REMARKS

The references cited by the Examiner along with the Examiner's comments have been diligently studied. Reconsideration of the application in light of this Amendment is respectfully requested.

Claim 1 has been amended. No claims have been added or cancelled. Therefore, claims 1-11 are under active consideration.

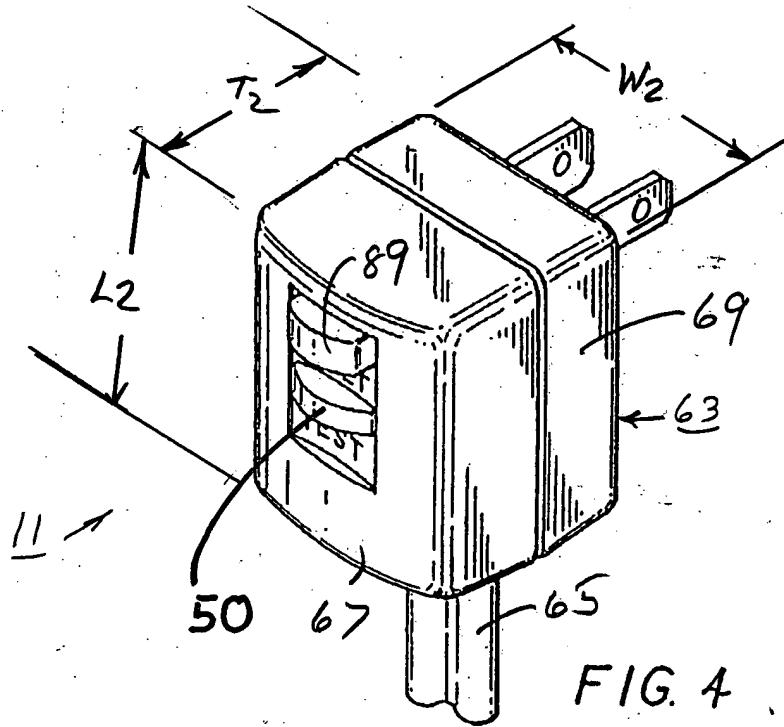
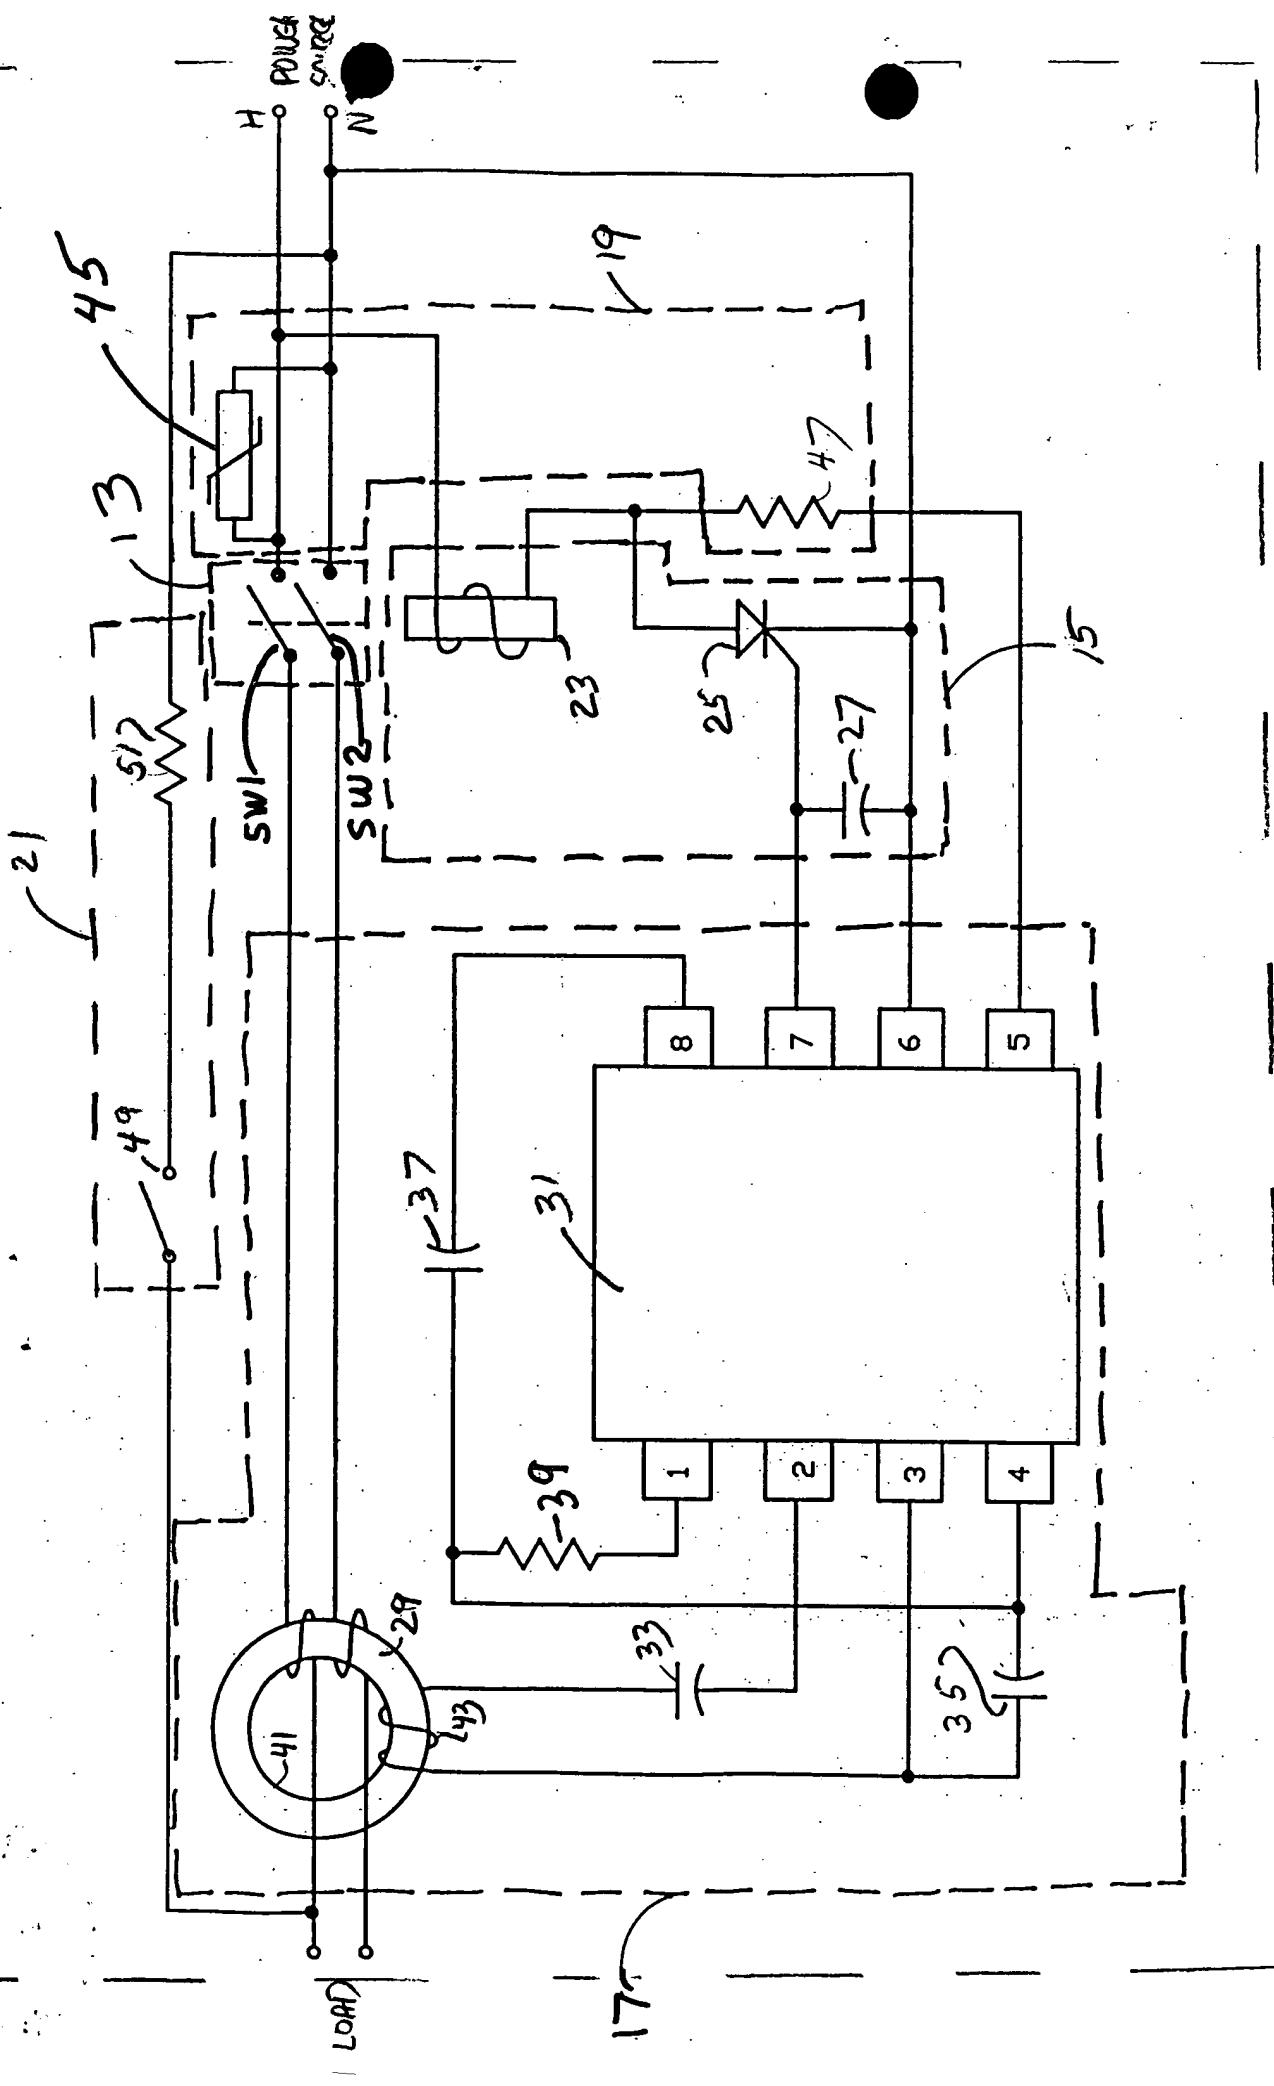
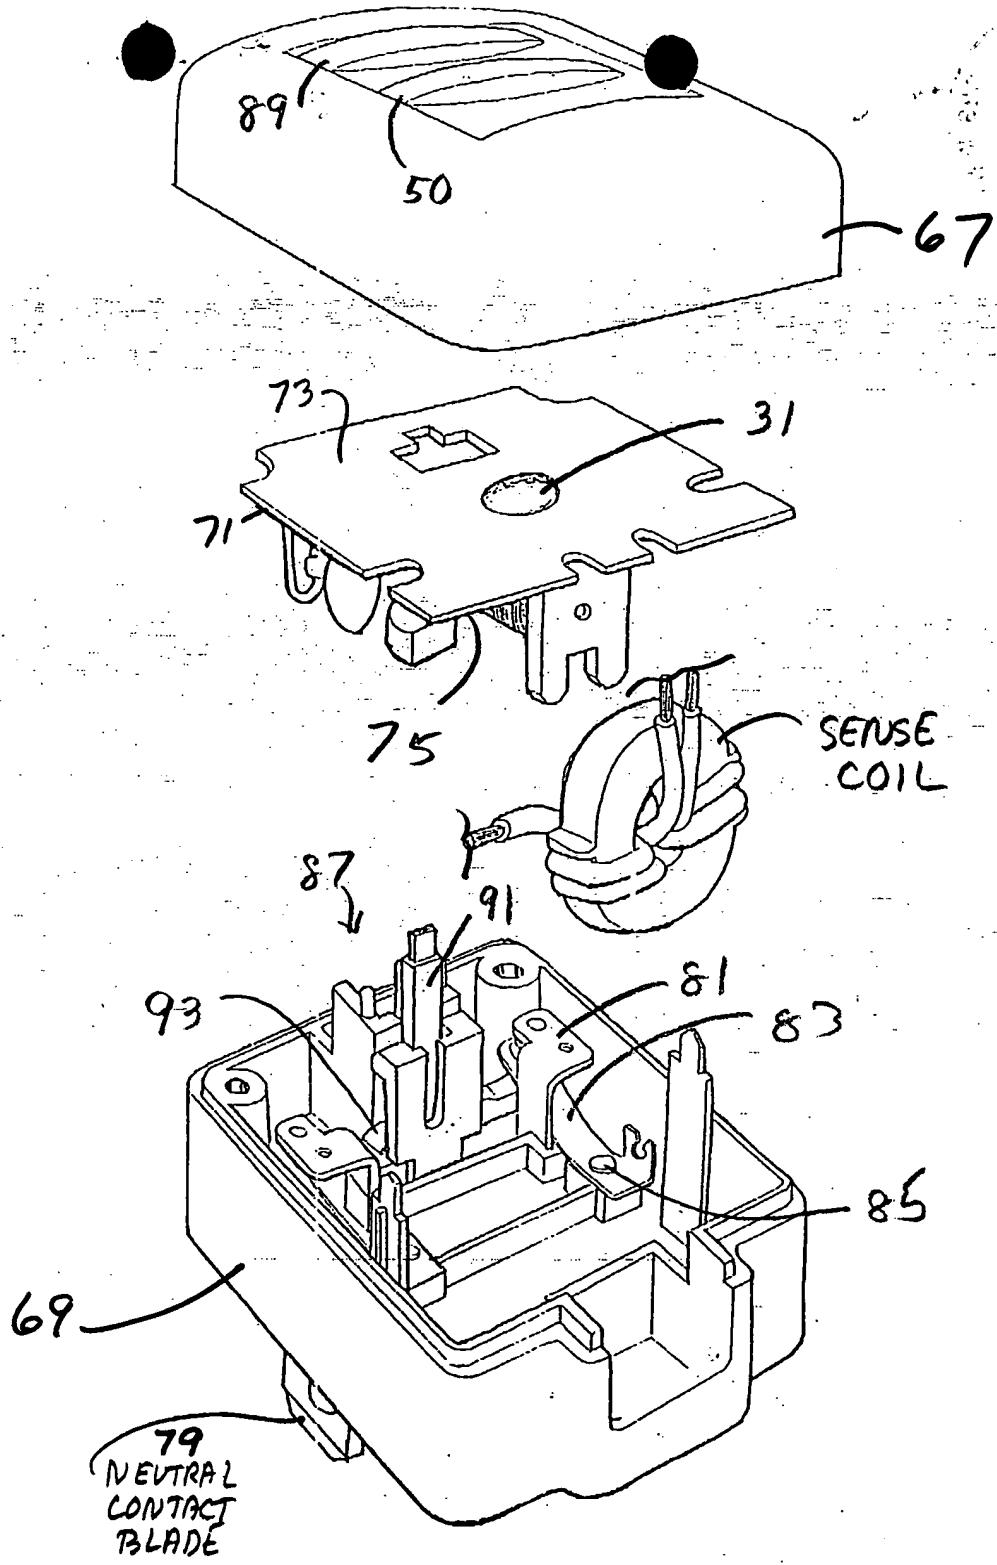
The drawings have been amended to overcome the objections noted by the Examiner in paragraphs 1 and 2 of the Office Action. Withdrawal of the objection is respectfully requested.
